Application of SOUTHERN CALIFORNIA ) EDISON COMPANY, <u>ET AL.</u> for a Class 103 ) License to Acquire, Possess, and Use ) a Utilization Facility as Part of ) Unit No. 2 of the San Onofre Nuclear ) Generating Station )	Docket No. 50-361 Amendment Application No. 116
--	---

This amendment application consists of Proposed Technical Specification Change No. NPF-10-407, Supplement 1 to Facility Operating License NPF-10. Proposed Technical Specification Change No. NPF-10-407, Supplement 1 is a request to revise Technical Specification 3/4.7.5, "Control Room Emergency Air Cleanup System." The proposed change will delete Surveillance Requirements 4.7.5.c.1, and 4.7.5.e.5, and revise Surveillance Requirement 4.7.5.b, the ACTION statement, and Bases.

REVIEW AND APPROVAL OF OL/POL PROPOSED CHANGE  
 SAN ONOFRE NUCLEAR GENERATING STATION -- UNIT NO. 2/3  
 PROPOSED CHANGE NO. NPF-10/15-407, Supplement 1

DESCRIPTION AND SAFETY ANALYSIS  
OF PROPOSED CHANGE NPF-10/15-407, SUPPLEMENT 1

SKETCH B

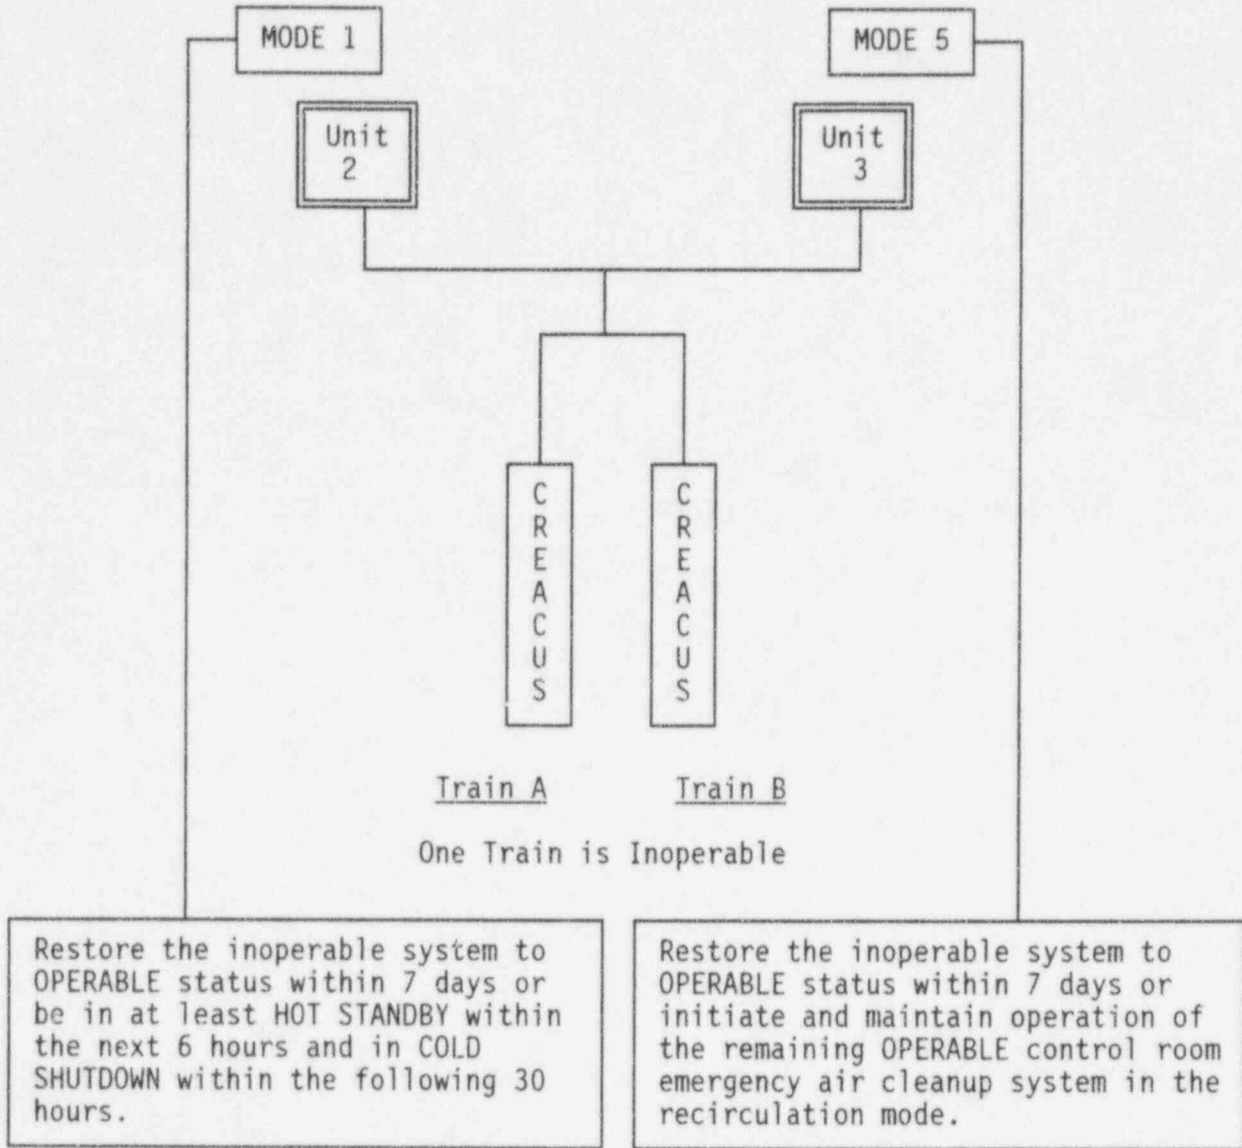
1. The NOTE " **Each Unit shall enter applicable ACTIONS separately**" was inserted before the ACTION statement.

The Technical Specifications do not address the operational situation when the Units are in different operational MODES. Because of different REQUIRED ACTIONS some confusion could take place. For example, if Unit 2 is in MODE 1 and Unit 3 is in MODE 5, the Required Actions for each Unit are not only different but conflicting (See Sketch B.). Without this NOTE it may not be clear what ACTION should be taken.

NOTE: This sketch is provided to illustrate Proposed Change #1, "Each unit shall enter applicable ACTIONS separately."

The proposed NOTE "Each Unit shall enter applicable ACTIONS separately" clarifies an operational situation when both Units are in different operational MODES.
